Product Change Notification

Change Notification #: 117716 - 00
Change Title: Intel® Server 1600W AC Common Redundant Power Supply AXX1600TCRPS, PCN 117716-00, Product Design, Label, Power Supply Firmware update
Date of Publication: July 29, 2020

Figure 1 Power Supply label before change

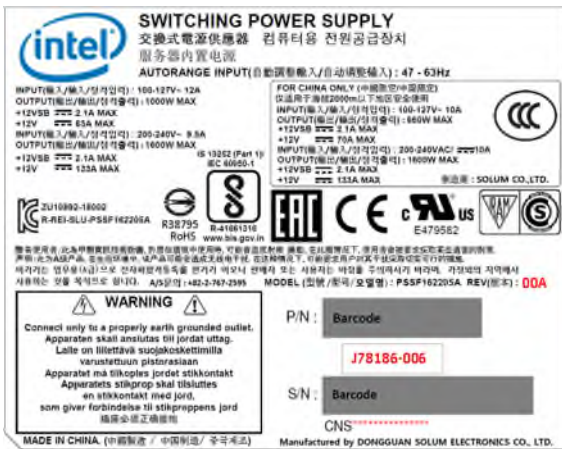
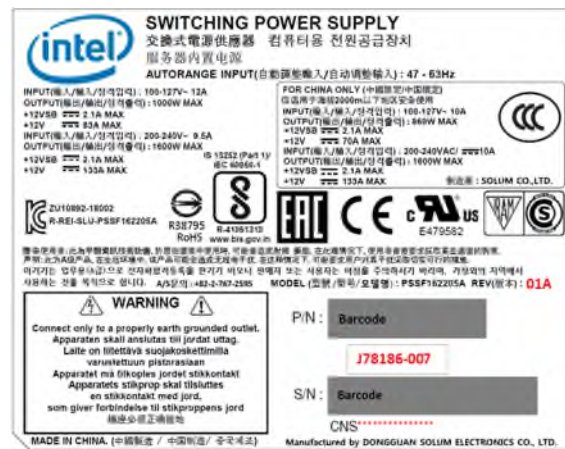
The firmware updates from 16.4.128 to 17.4.128 and changes Power Supply revision from 00A to 01A and the Product Number from J78186-006 to J78186-007
